# City of San Antonio

Re: Carmona Hills (Amended)

**MDP # 049A-06**

The City Staff Development Review Committee has reviewed the Carmona Hills Master Development Plan **M.D.P. # 049A-06**. Please find enclosed a signed copy for your files. Your plan was approved for acceptance; however please note the following conditions:

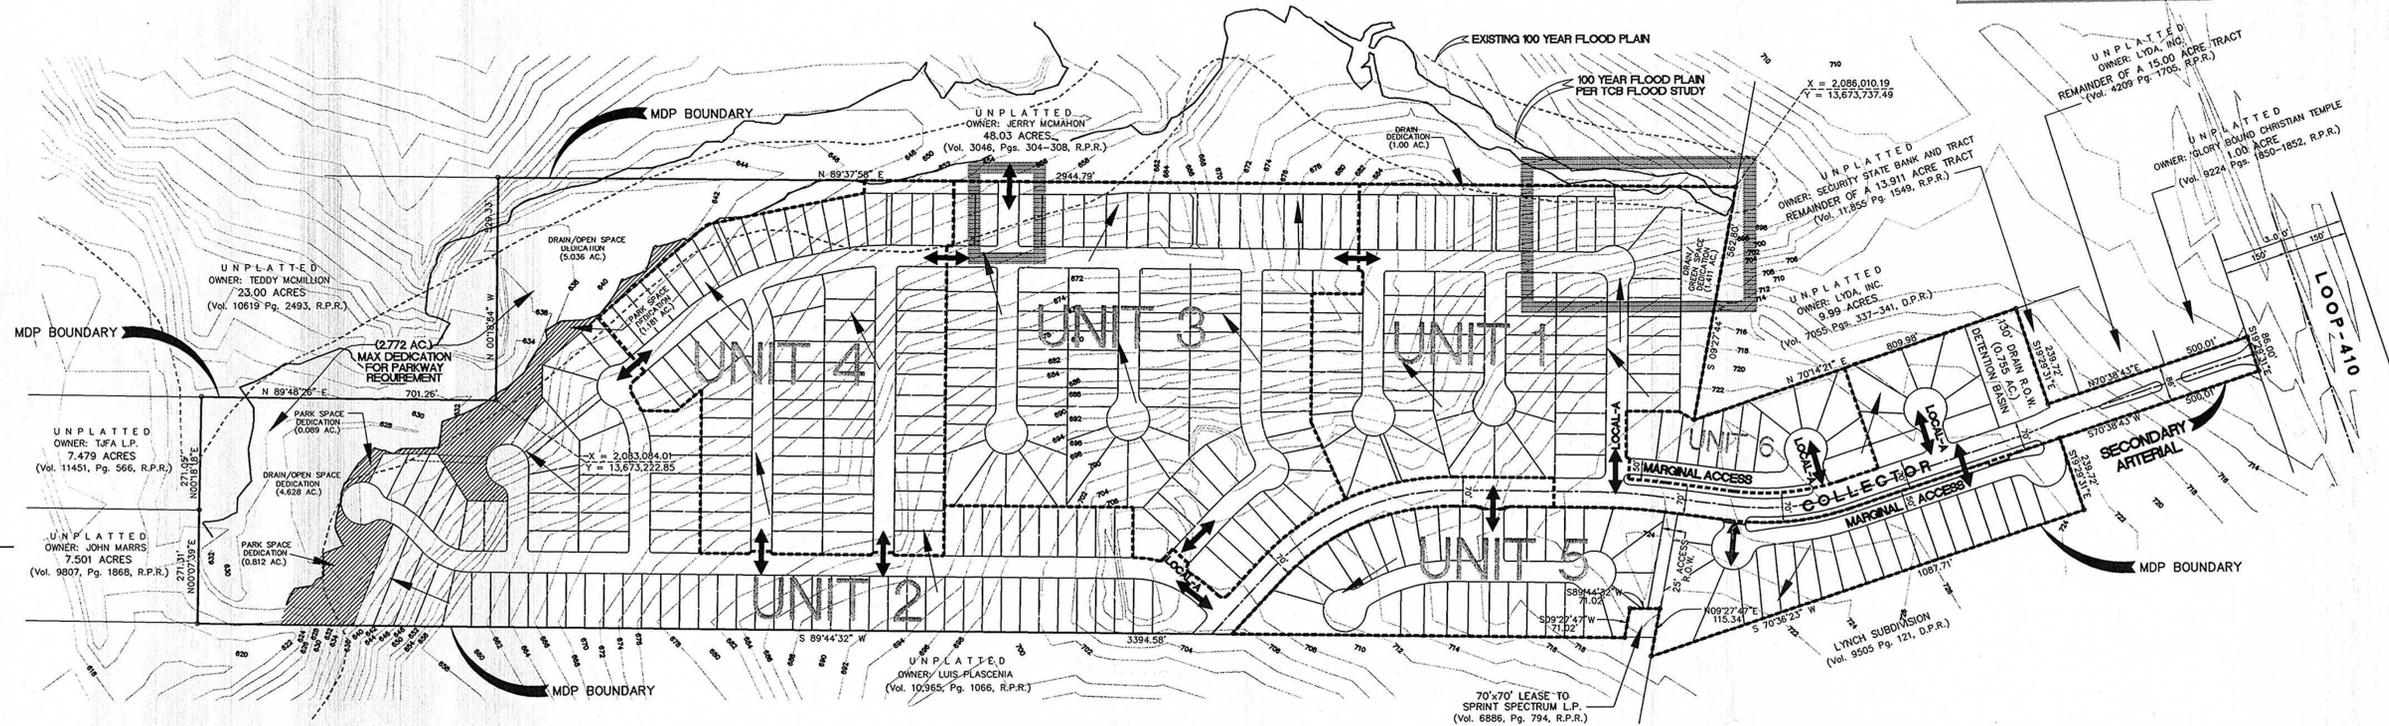
In consideration of public safety and convenience, excessive grades by reason of topography should be avoided in street layouts and arrangements. Any access and R.O.W. issues along state facilities will need to be resolved with the **Texas Department of Transportation (TXDOT)**. For information about these requirements you can contact TXDOT at 615-5814.

- All access driveways shall comply with UDC 35-506 (r).
- All roadways shall conform to Table 506-2 Functional Classification System Description for Traditional Design Classification.
- All sidewalks shall comply with UDC 35-506 (q).
- All access roadways shall provide clear sight distance on all existing and proposed roadways in order to provide adequate obstruction free viewing distances from approaching traffic. All signage, landscaping, and improvements shall be selected and located so as to not block these clear sight distances areas.
- A right turn deceleration will be required to be installed as per TxDot requirements.

- The parkland provided shall be shown as “Park” or “Open Space” on a plat; UDC section 35-503(e) *Designation of Parkland*.
- The parkland provided is dedicated to the Homeowners Association.
- The instruments creating the Homeowners Association are provided by the second application for plat approval; UDC section 35-503(e) *Designation of Parkland*.
- Parkland dedication shall be platted by the second phase of residential development; UDC section 35-503 (f) *Development Phasing*.
- All amenities provided shall comply with standards and specifications found in UDC section 35-503(h) *Credit Park Facilities* and Table 503-4 if any credit is to be awarded.

- 2003 Tree Preservation ordinance standards per UDC Section 35-523 – a Master Tree Permit (AP 1301746) has been issued for this project using the Tree Canopy Method – no removal permitted in flood plain and plan indicates 45% preservation on site. A \$75 fee will be charged at platting for follow-up inspections.
- Streetscape standards per UDC Section 35-512 – The Secondary Arterial and Collector streets to be constructed require streetscape trees. Estimates of planting costs and plan and profiles for streetscape will be required at platting stage.
